UNITED STATES PATENT AND TRADEMARK OFFICE

10/576,258

Office Action Summary	Application No. 10/576,258	Applicant(s) MASAMURA ET AL.	
	Examiner MARINA TIETJEN	Art Unit 3753

DETAILED ACTION

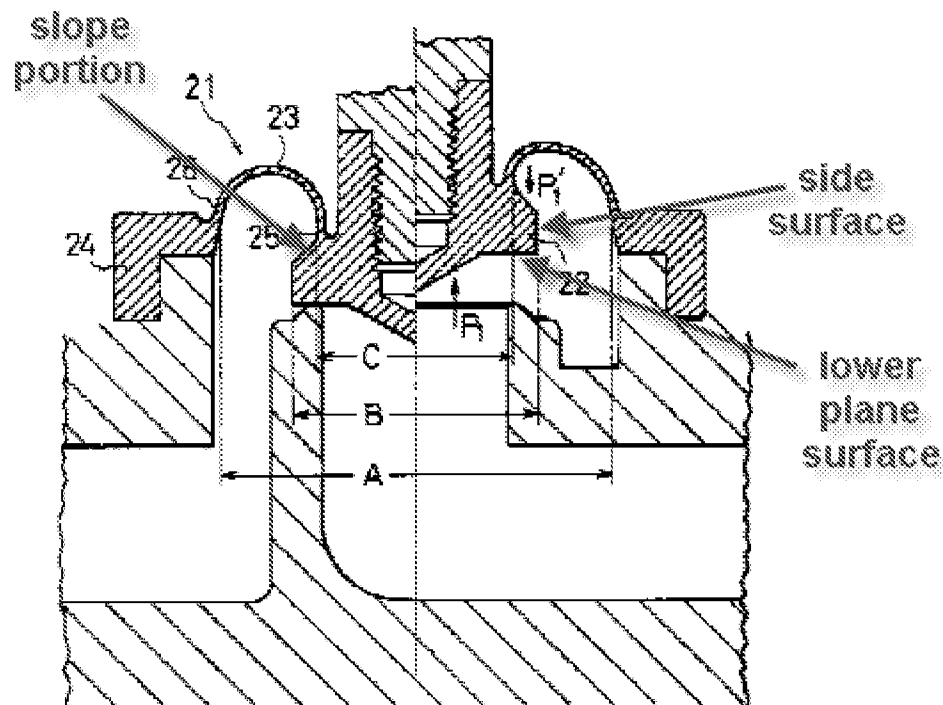
Kimura discloses a diaphragm valve (fig. 1) comprising:

a body (1) having an upper opening (in which diaphragm 21 seals);

a first flow passage (3) and a second flow passage (2) formed in the body (1) to open into the upper opening;

a diaphragm valve element (21) covering the upper opening to form an airtight space through which the first and second flow passages (3, 2) are allowed to communicate with each other;

a valve seat (5) formed in the body (1);

an urging member (14) urging the diaphragm valve element (21) against the valve seat (5) into a valve-closed state; and

an actuator (11, 12, 20 in combination with air pressure through 15) adapted to bring the diaphragm valve element (21) out of contact with the valve seat (5) into a valve-opened state;

【圖 2】

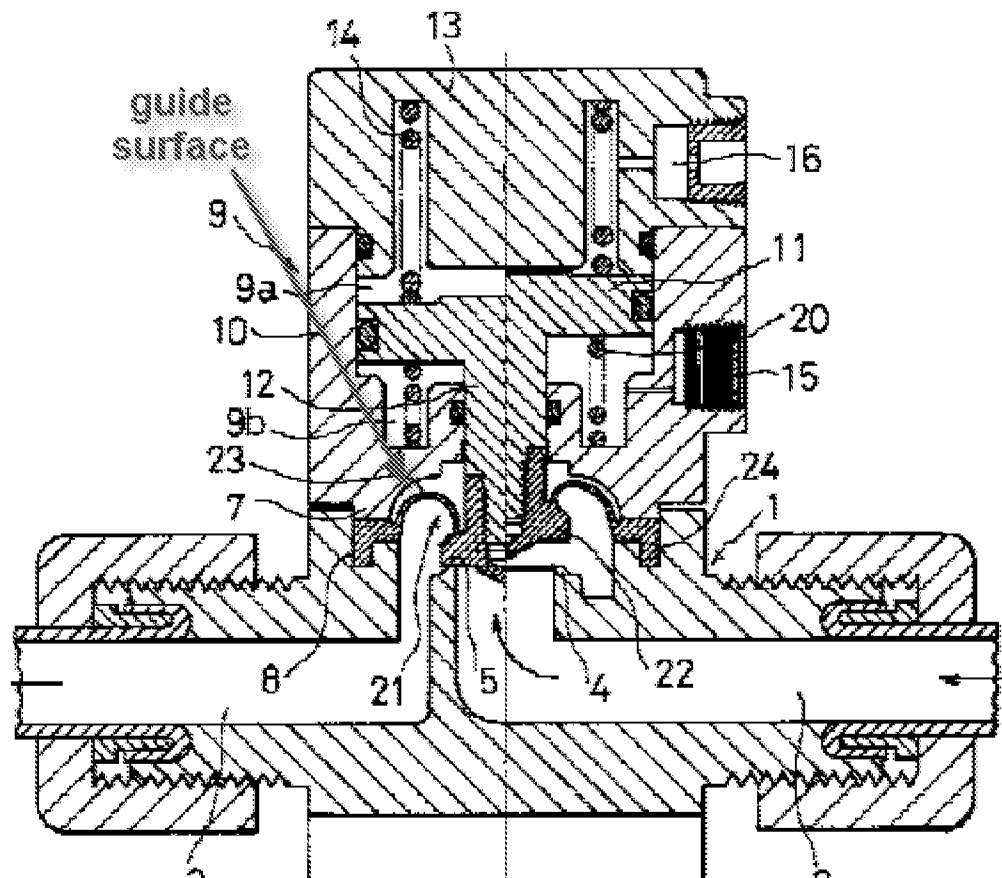
a main body (22) which is to be brought into/out of contact with the valve seat (5), the main body (22) including a lower plane surface (see labeled fig. 2 below) for being in contact with the valve seat (5), a side surface (see labeled fig. 2 below) vertically extending from an outer periphery of the lower plane surface (labeled fig. 2 below), a hole opening (threaded hole in which 12 fits) on an upper

surface in which the actuator (11, 12, 20) is fitted, and a slope portion (see labeled fig. 2 below) connecting an upper end of the side surface and an outer periphery of the upper surface;

a diaphragm part (23) formed extending in a curve, radially from the slope portion of the main body (22), and including a root (25) connected to the main body (1), a radially outer portion of the root (25) being positioned inside the diameter of the valve seat (C is shown as outer dimension of root which is located slightly inside of seat 5 as shown in fig. 2) so that liquid pressure acts on a region outside the root connected to an upper surface of the main body for reducing an urging force of the urging member, the diaphragm valve being capable of reducing an occurrence of water hammer; and
